SUBJECT: ADDITIONAL SAFETY AND ENVIRONMENTAL QUESTIONS - VOGTLE PLANT

Plant Name: Vogtle Electric Generating Station
Licensing Stage: OL
Docket Nos.: 50-524/525
Project Manager: M. Miller

Hydrologic Engineering Safety Questions
Vogtle Station, 50-524/525

COMPACTION TEST

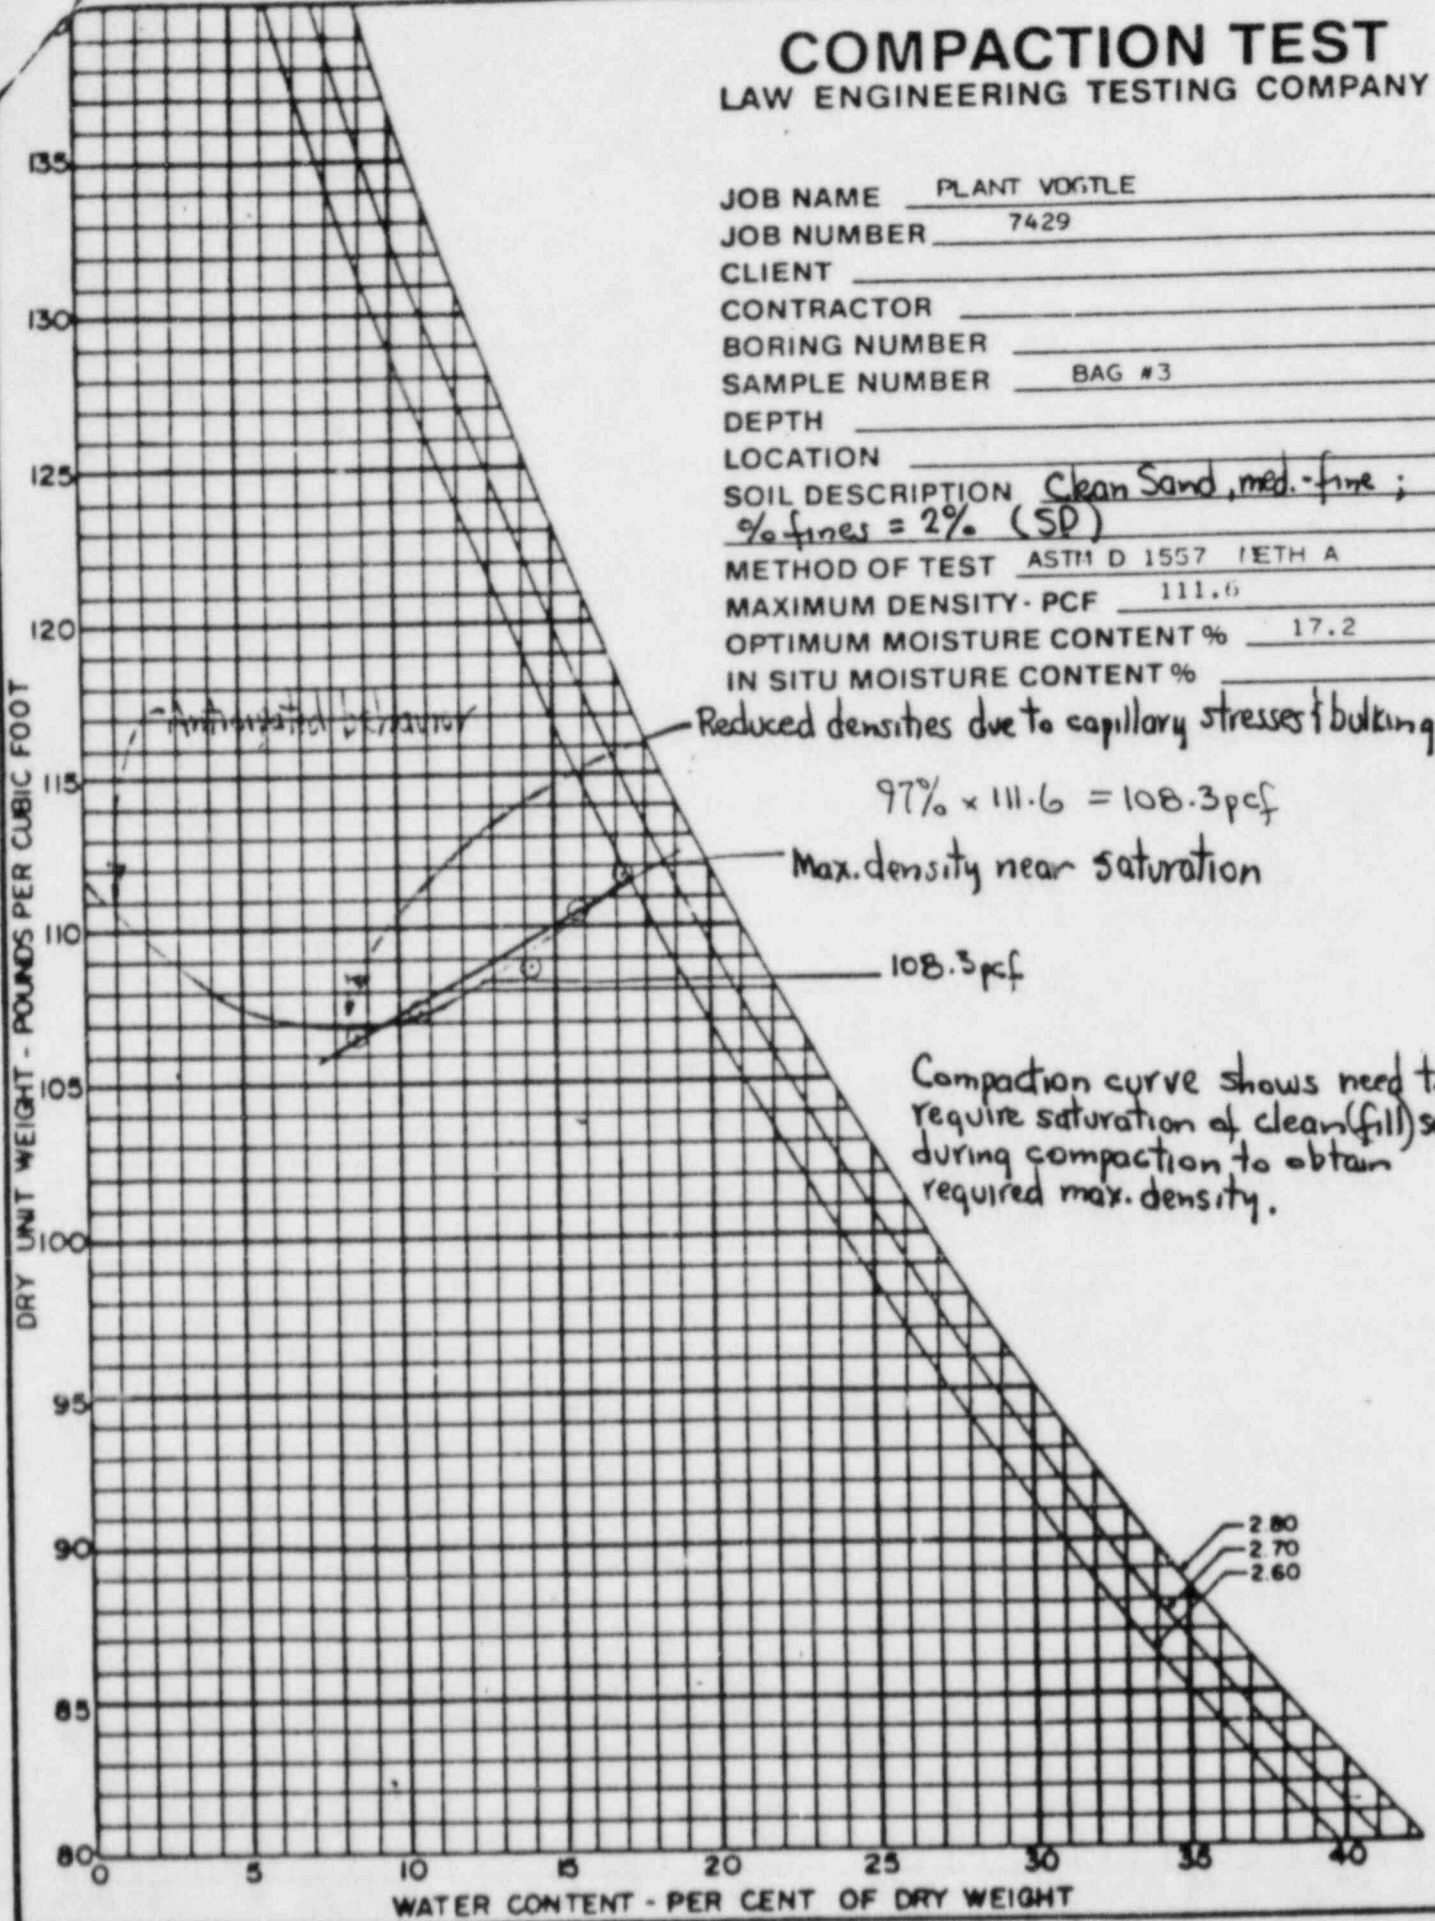
Compaction curve shows need to require saturation of clean (fill) sand during compaction to obtain required max. density.

COMPACTION TEST

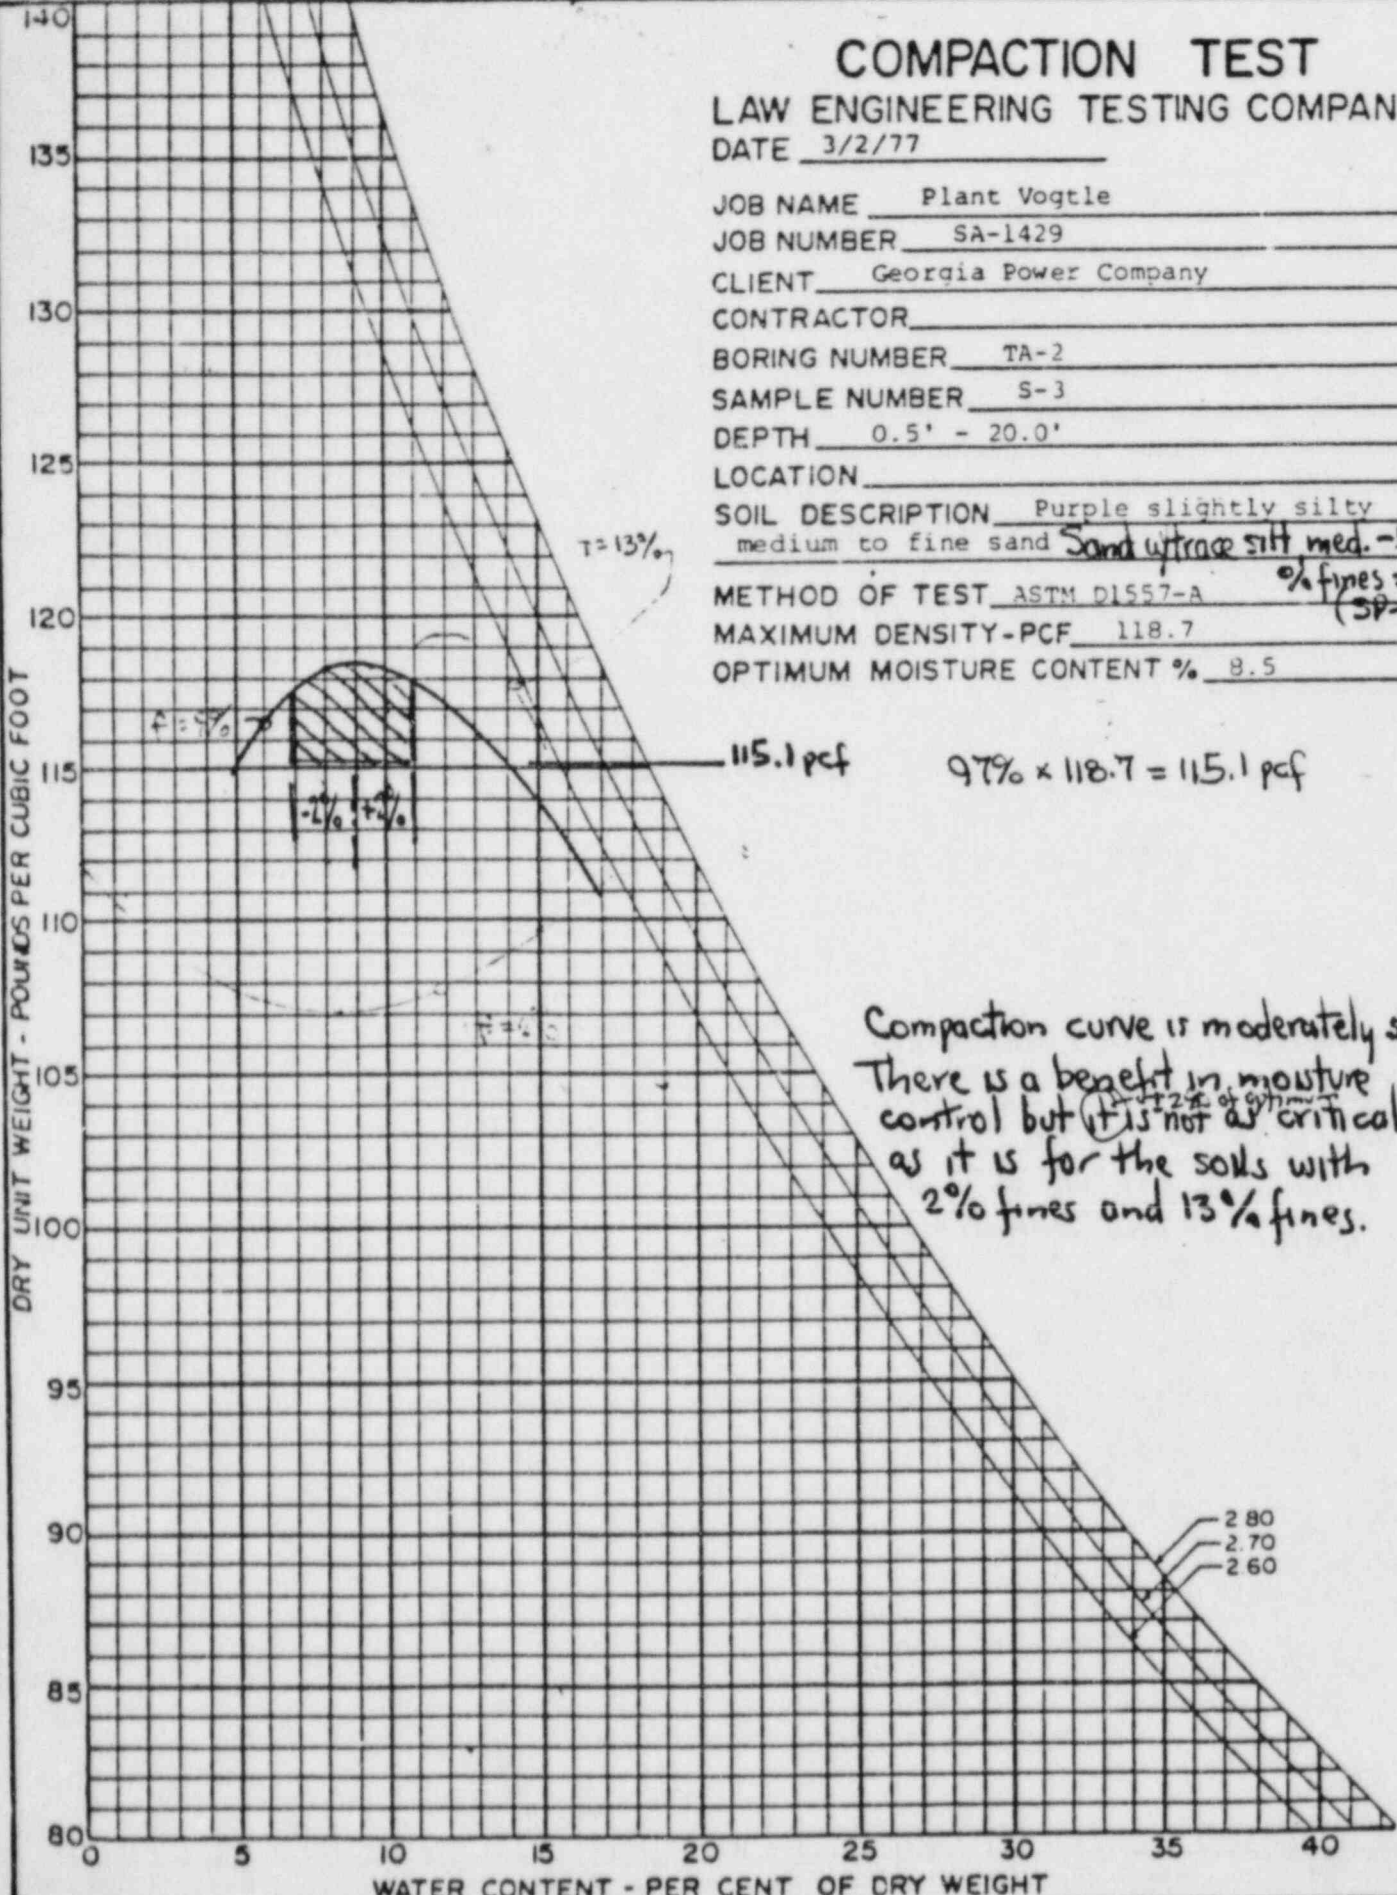
Compaction curve is moderately steep. There is a benefit in moisture control but it is not as critical as it is for the soils with 2% fines and 13% fines.

COMPACTION TEST

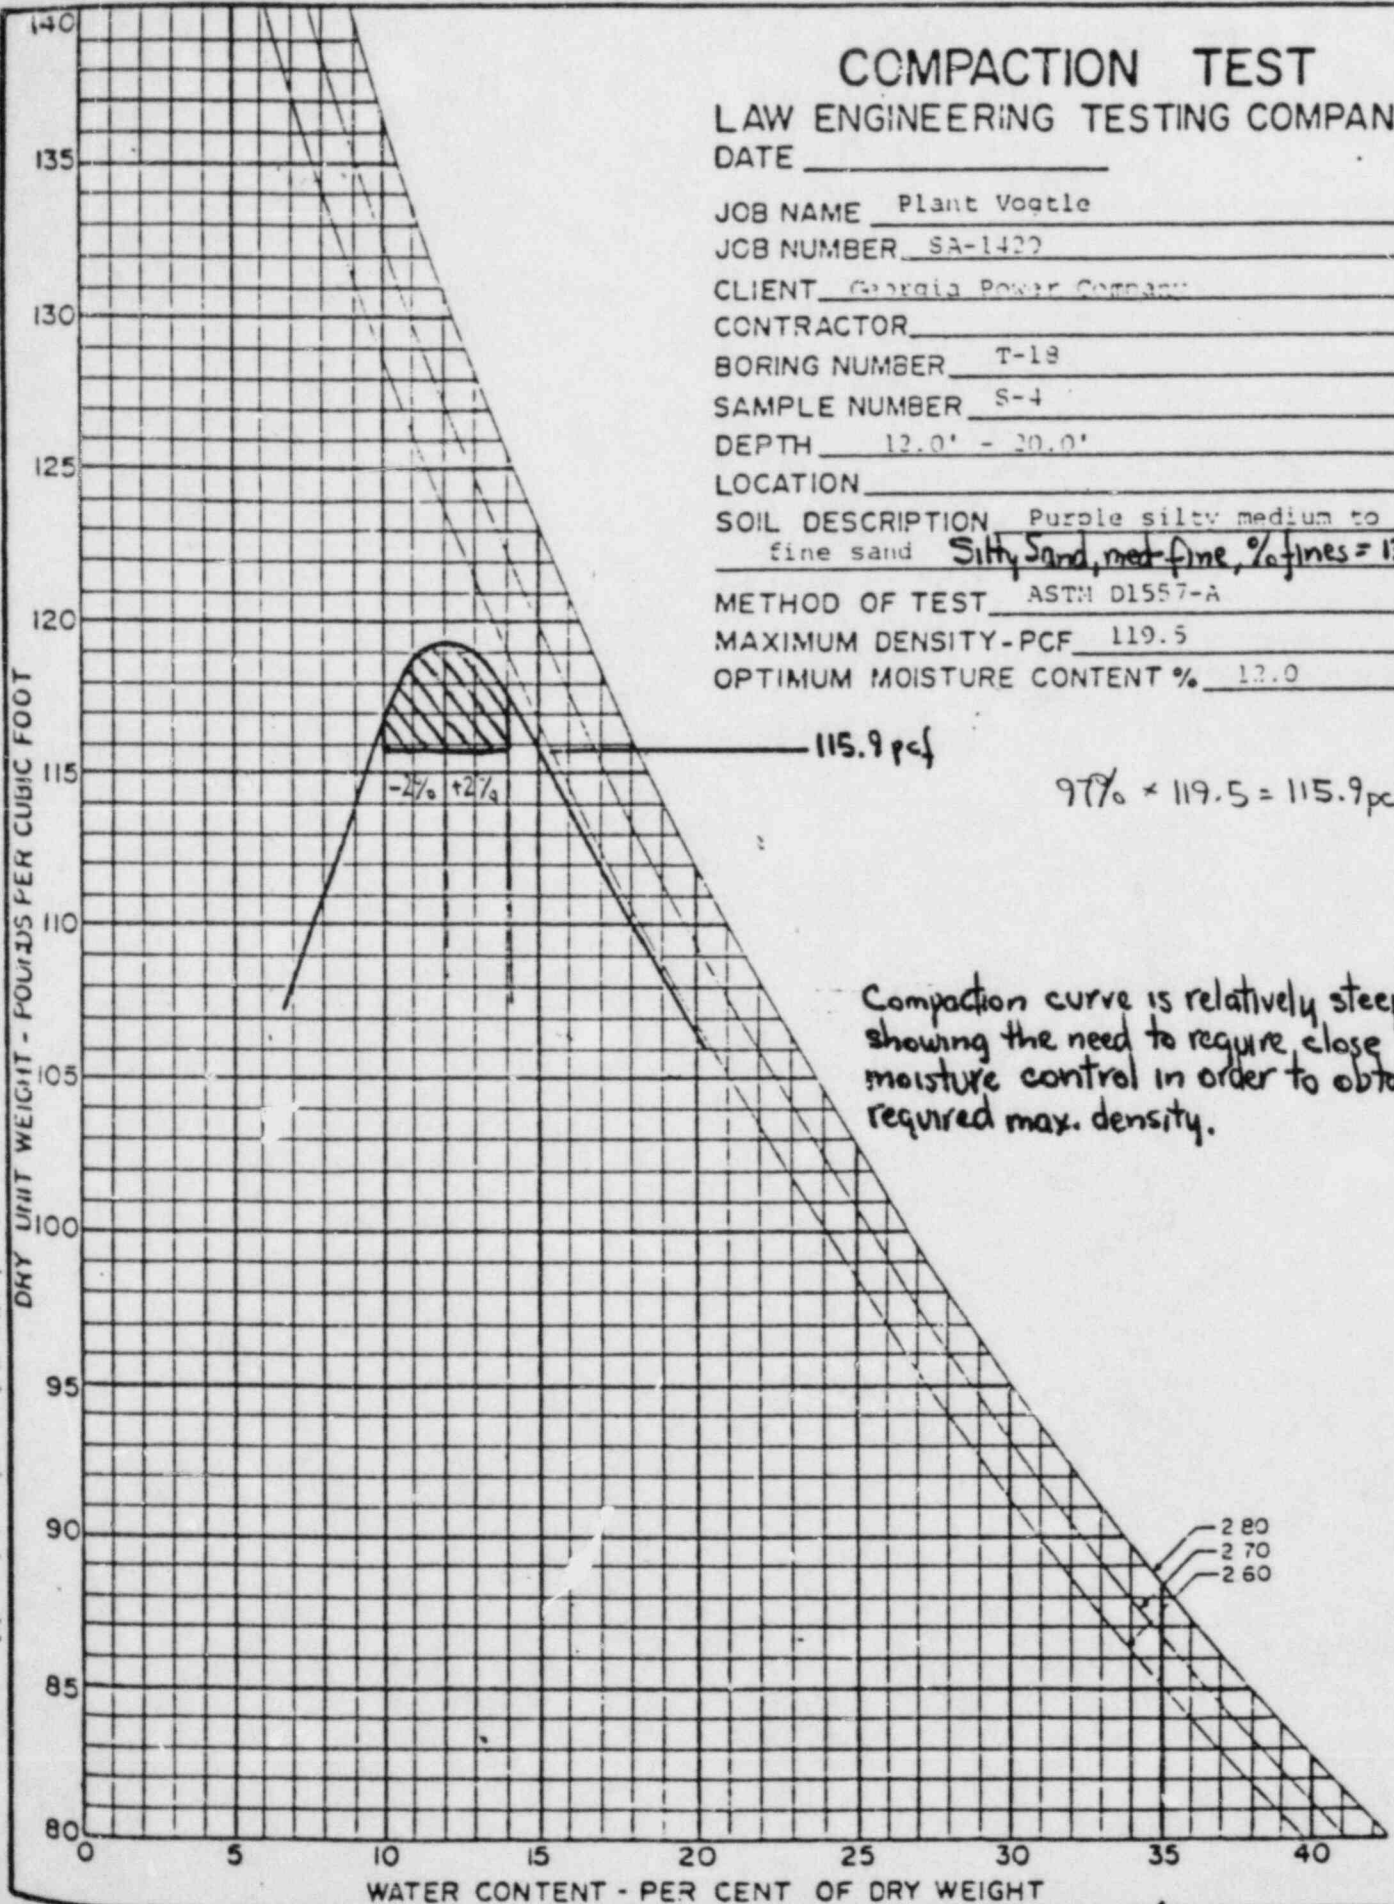
Compaction curve is relatively steep showing the need to require close moisture control in order to obtain required max. density.
